Re: Port Ewen Fire District

Port Ewen Firehouse Construction Project

Addendum #3

1 FIRST FLOOR FRAMING PLAN
S101 1/8" = 1'-0"

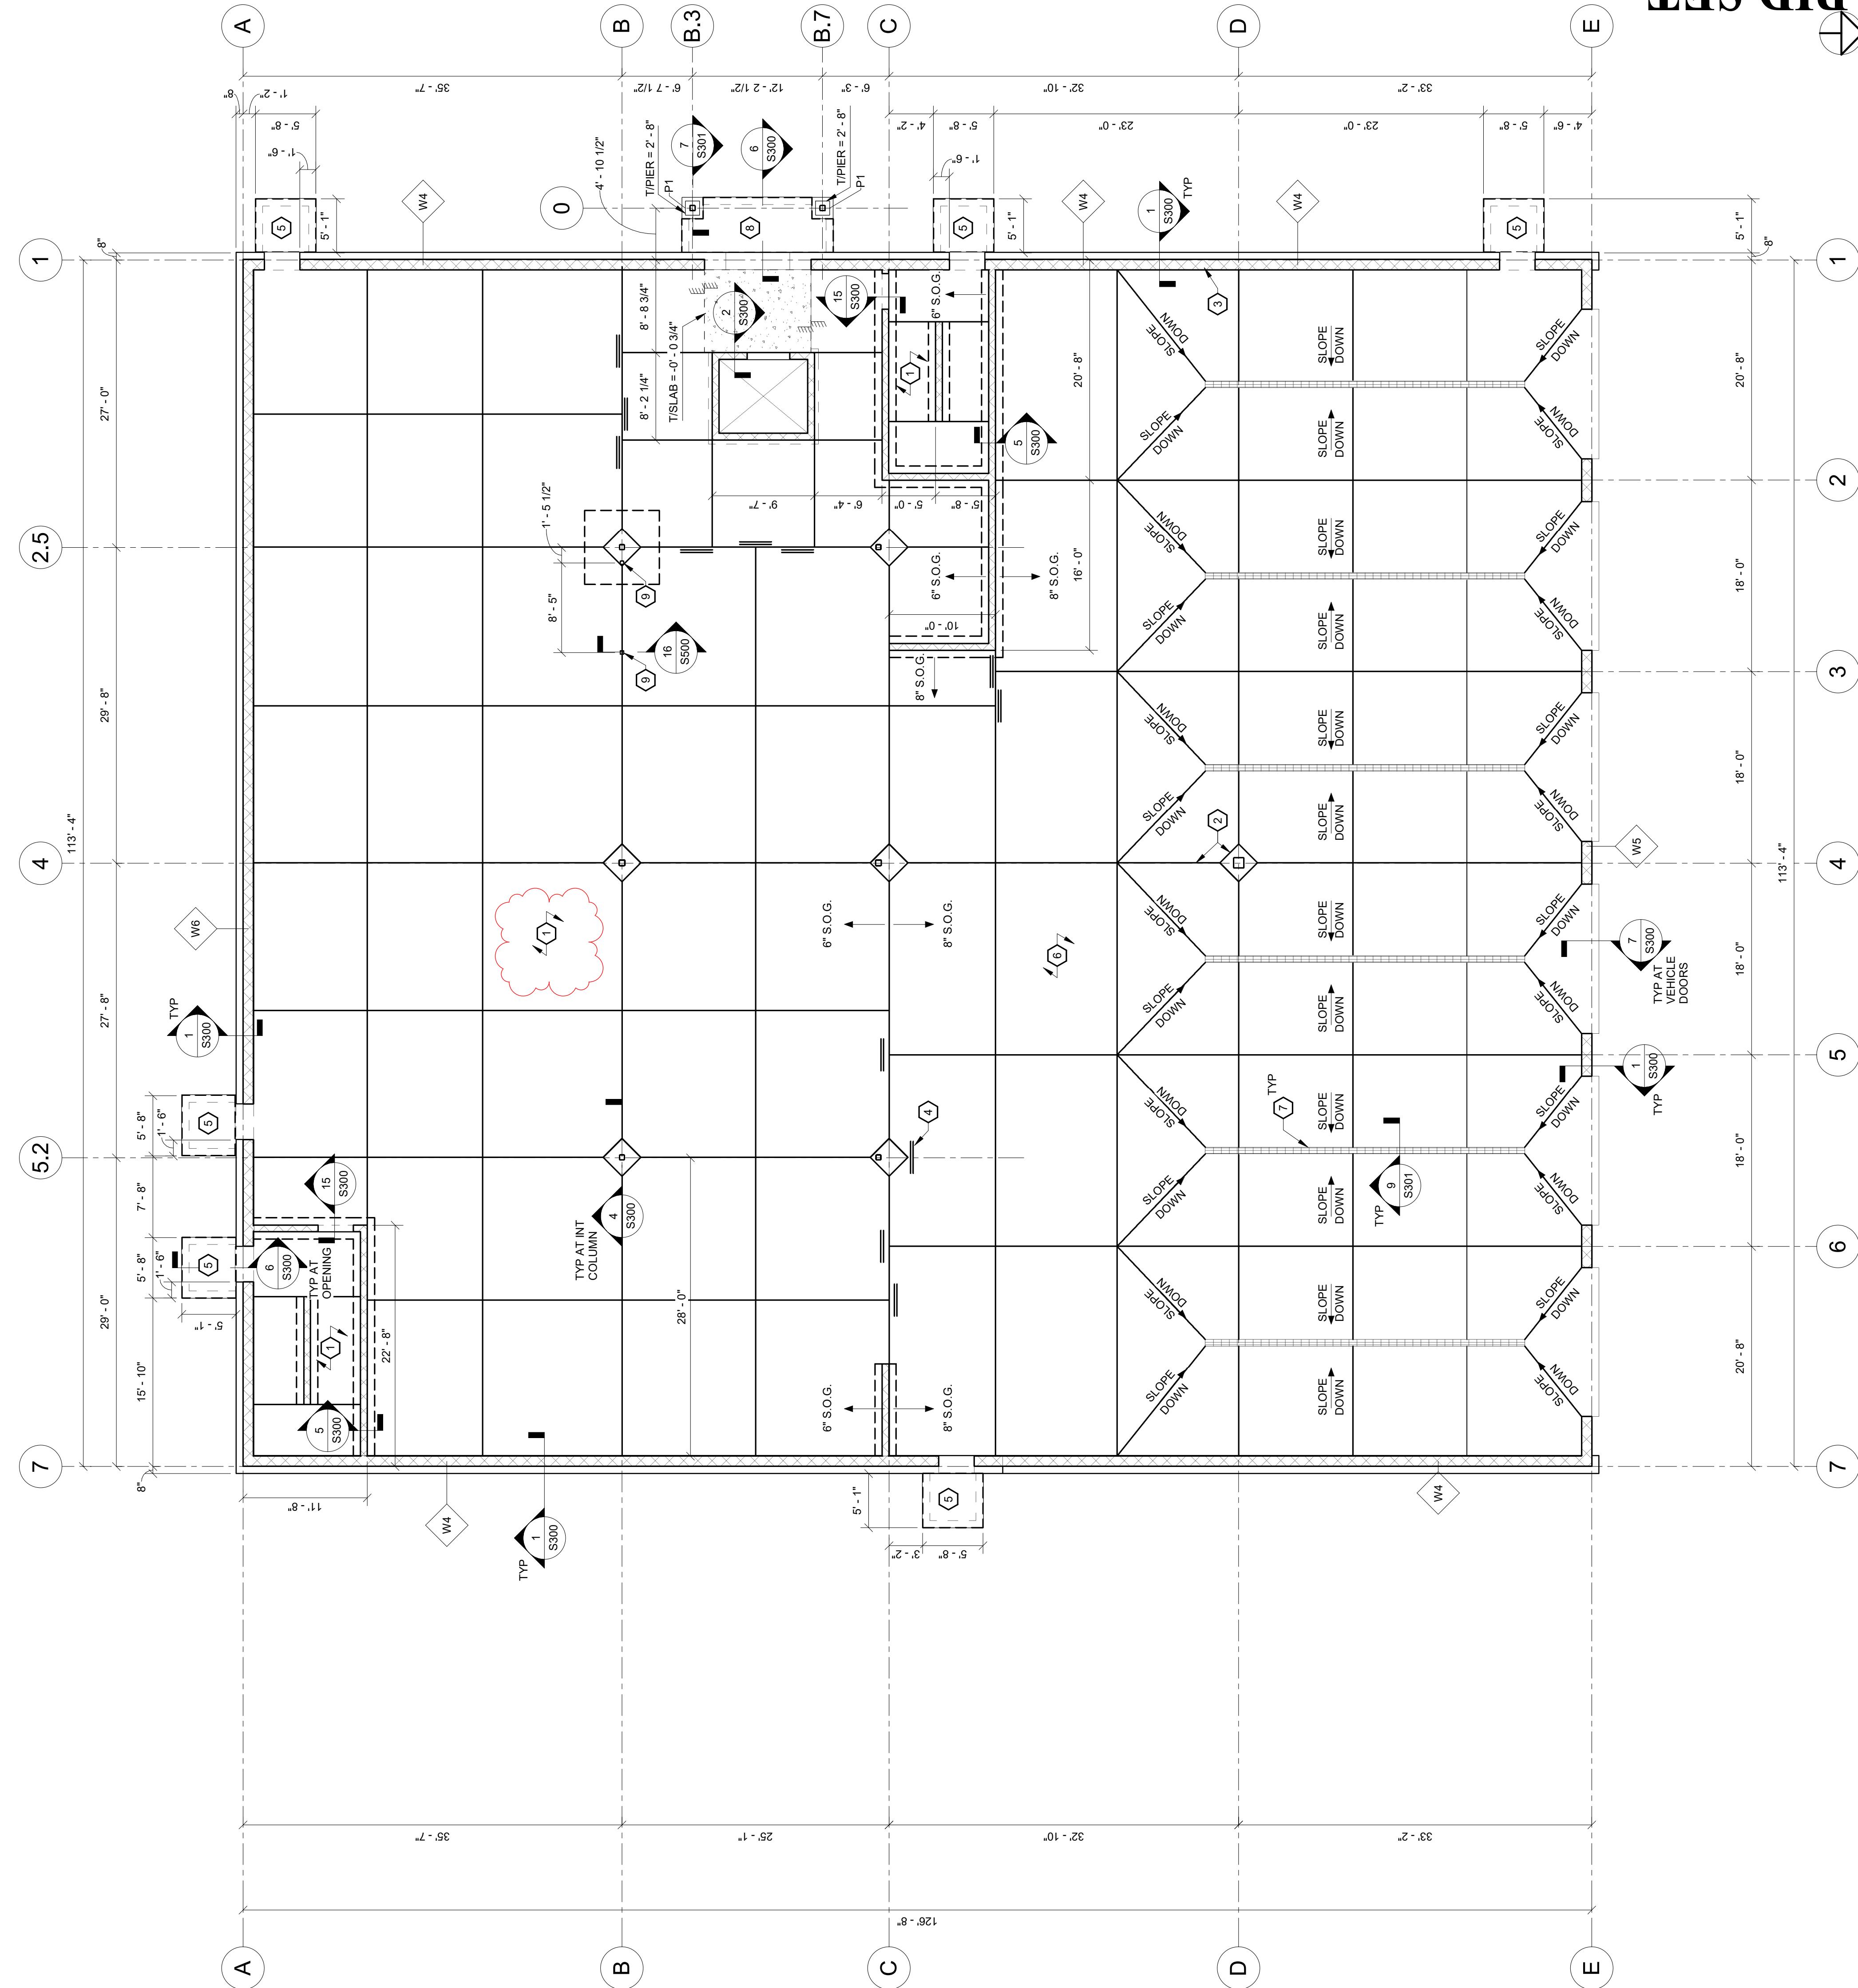
- See revised sheet attached.

SHEET:
S101A

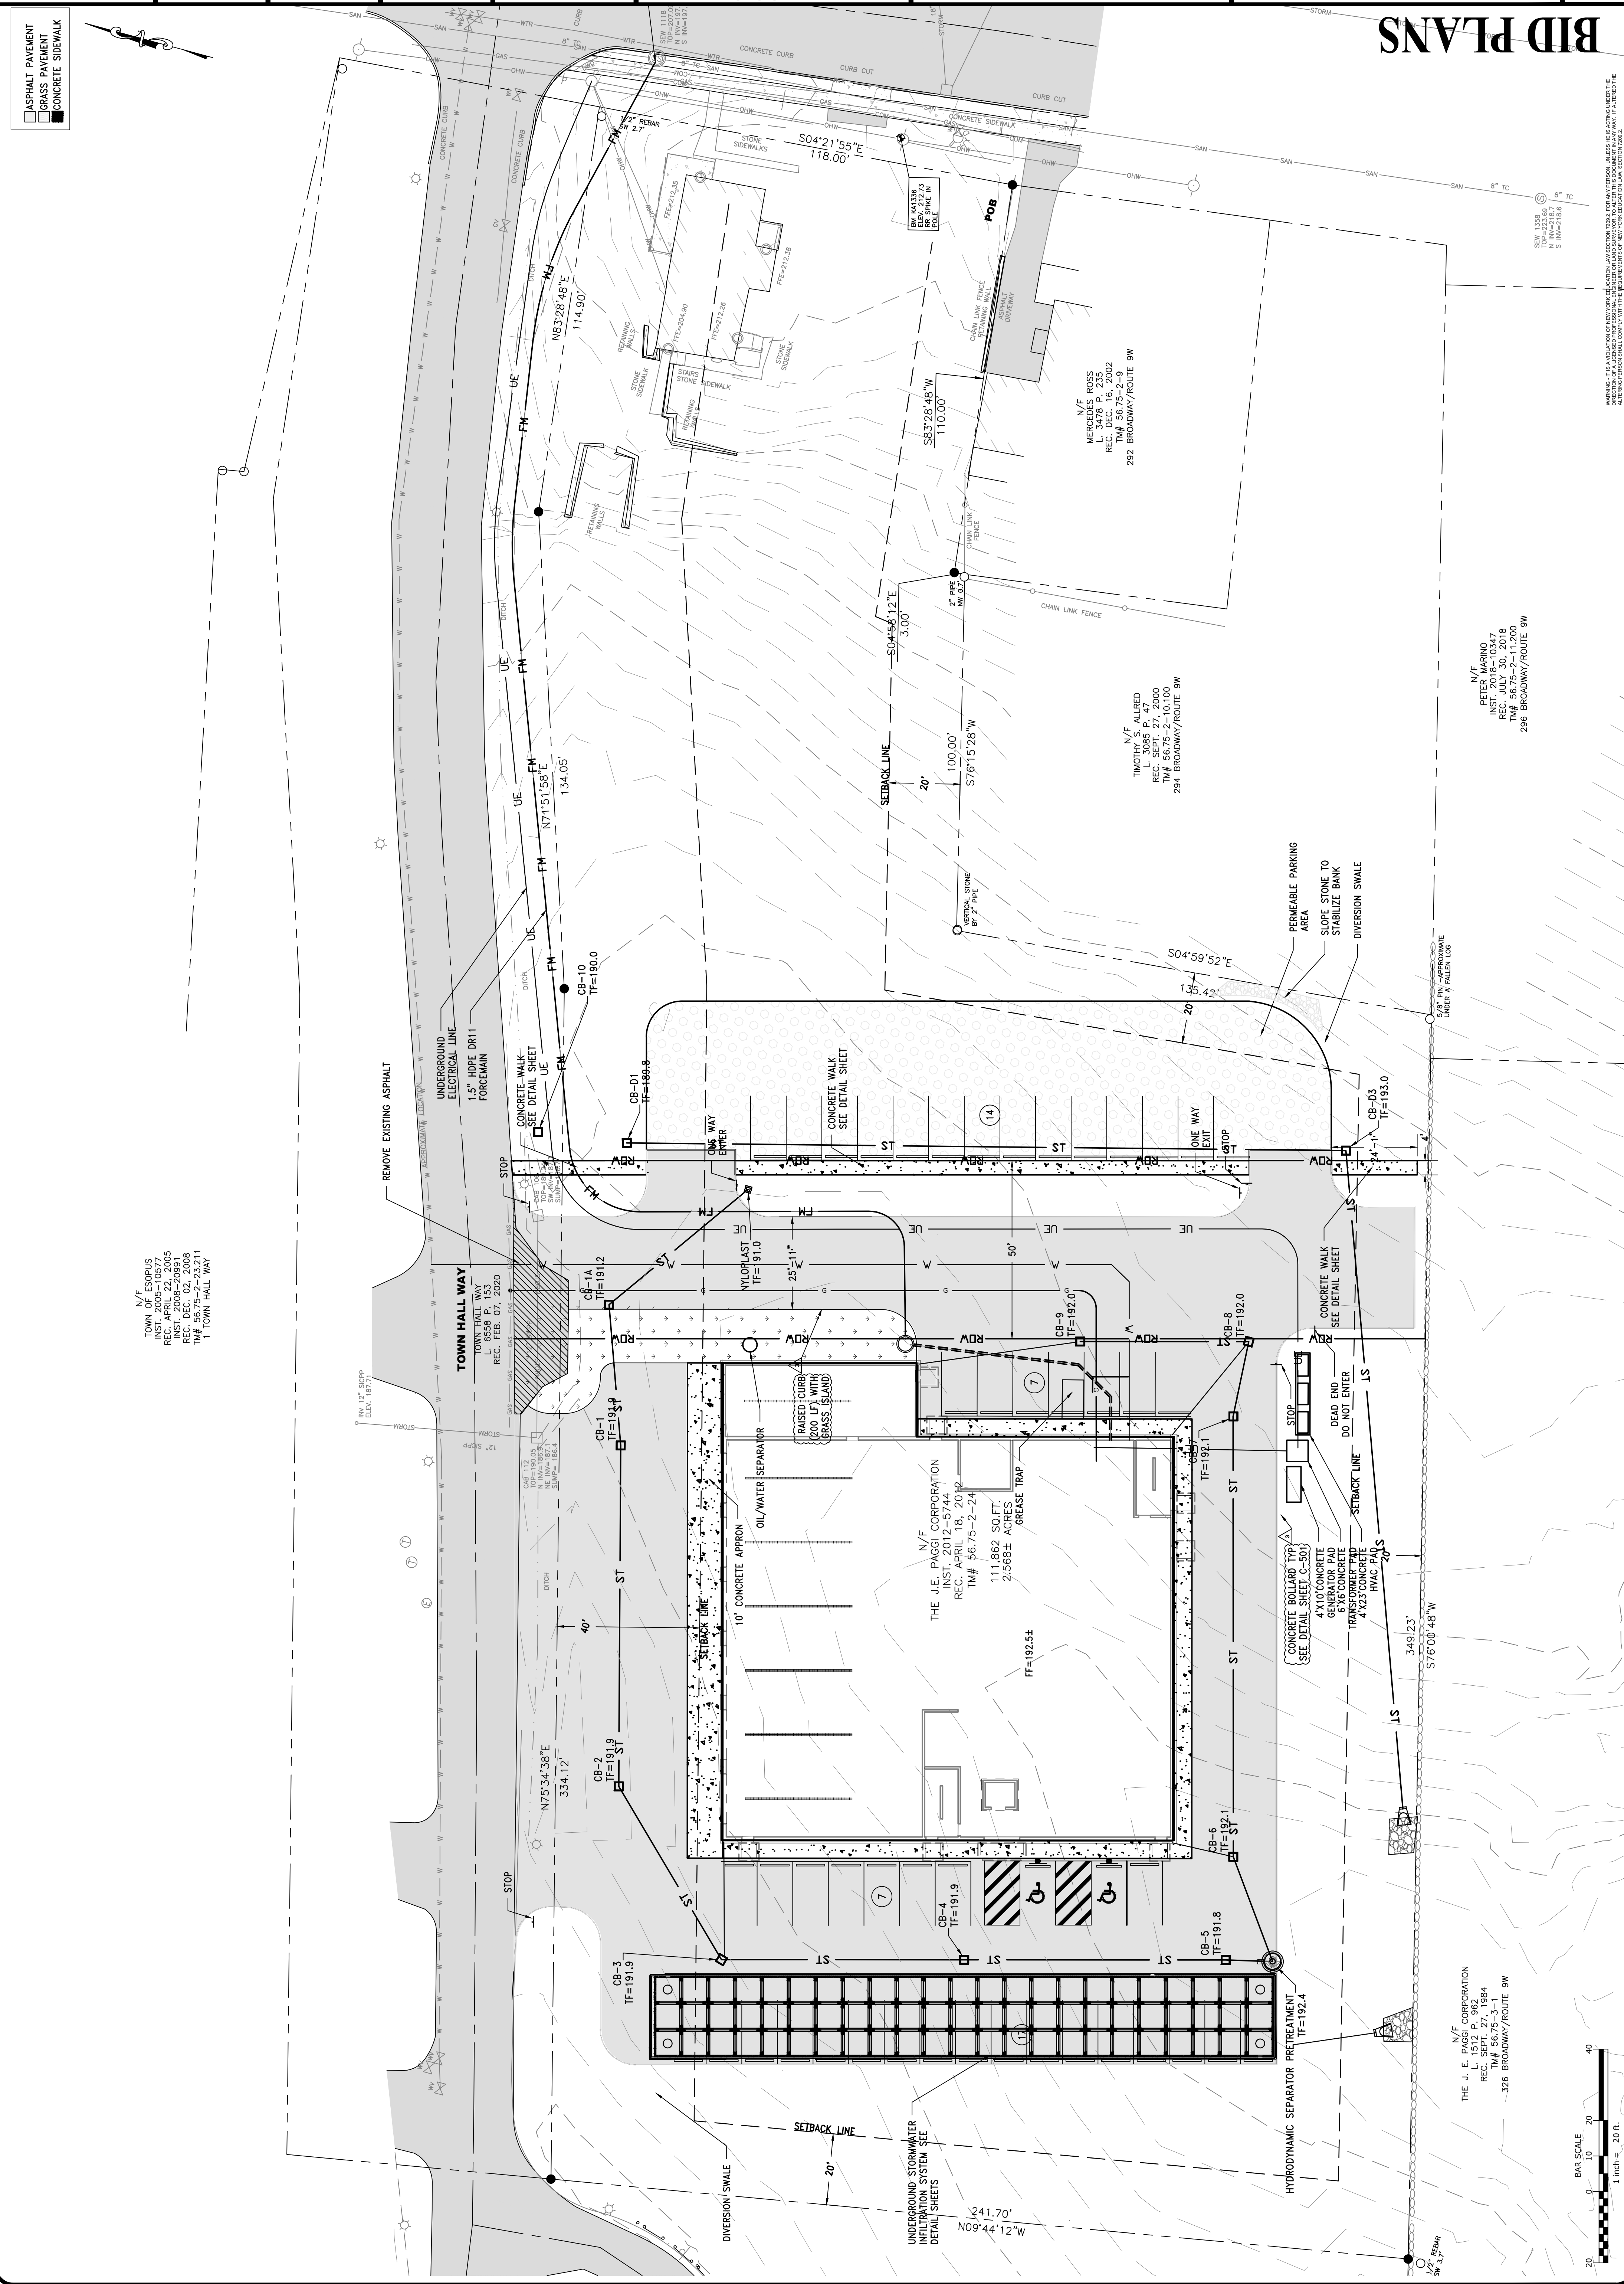
- See revised sheet attached.

PROPOSED UTILITIES

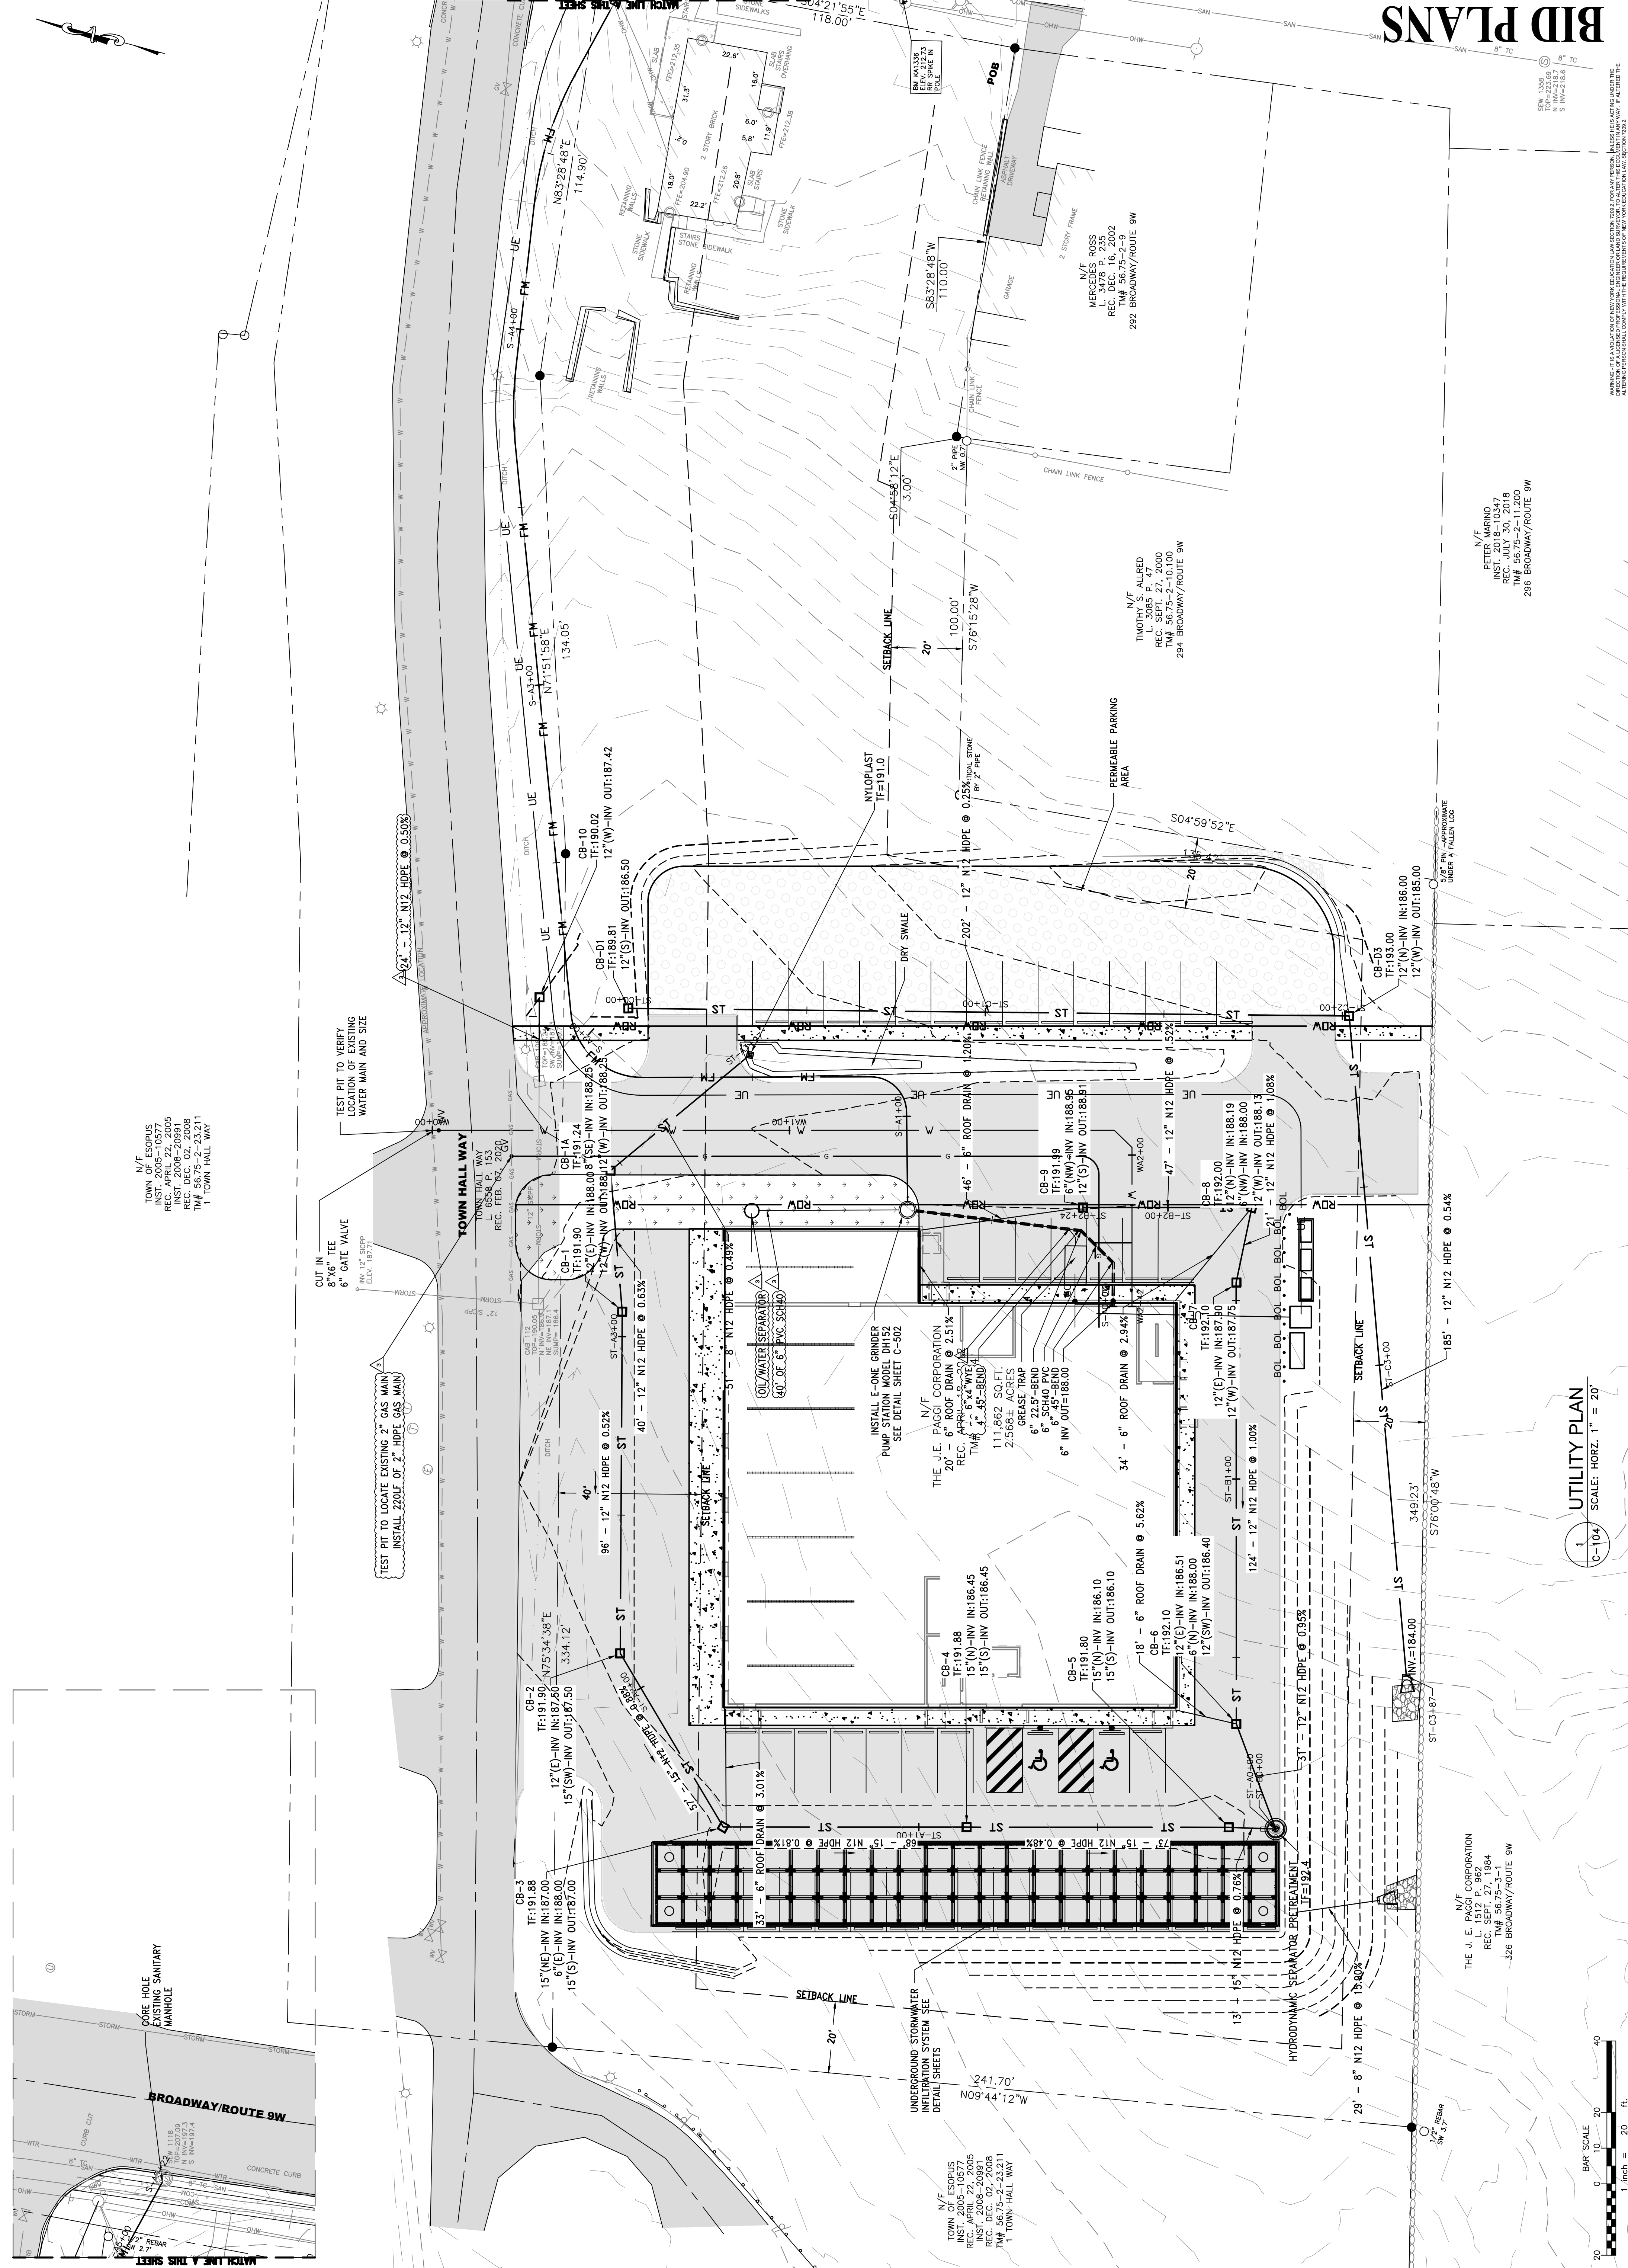
- Added piping connection to gravity sewer for Grease Trap shown on drawing C-104.
- See revised sheet attached.
